Staff Report & Recommendation

Design Review Board

SUBJECT: DRB16-0059
40 Island Avenue—Standard Hotel and Spa

2016 Aerial photo depicting existing spa deck, finger pier conditions and outdoor dining area deck at rear of property

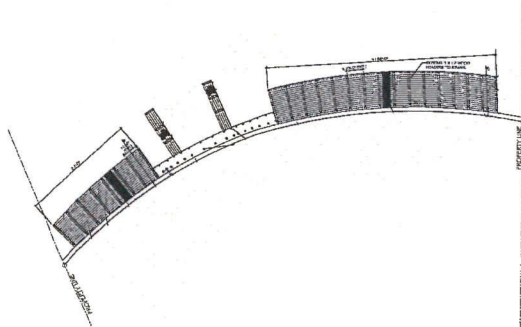
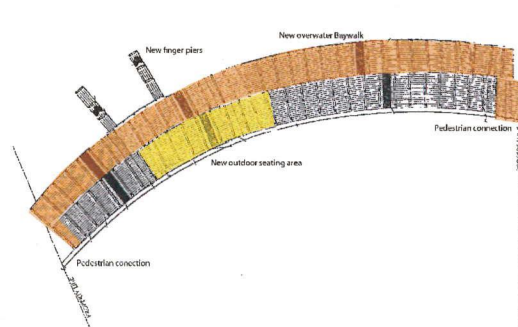
The existing conditions of the decks and piers that currently project into Biscayne Bay along the rear of the Standard Hotel, create a complicated and challenging plan in order to accommodate the Baywalk. At this time, staff is recommending that the proposed Baywalk be continued to a future meeting date, in order to address the following specific areas:

- Fill-in the portion of seaward decking between the existing spa deck to the west and the outdoor dining deck to the east;
- provide a continuous Baywalk connection, 15'-0" in width, extending seaward along the northern side of the site (now a continuous 24'-0" of decking) a minimum of 15'-0" to match the width of the Public Baywalk along the edge of Biscayne Bay;
- relocate existing boat slip piers;
- provide connection point to future Baywalks and connection point to Island Avenue.

The incorporation of a Public Baywalk into the eventual reconstruction of the property's docks and boat slops is a reasonable accommodation that would be implemented in the overall scope of the extensive site work, which includes an overlay district and a complete new wing.
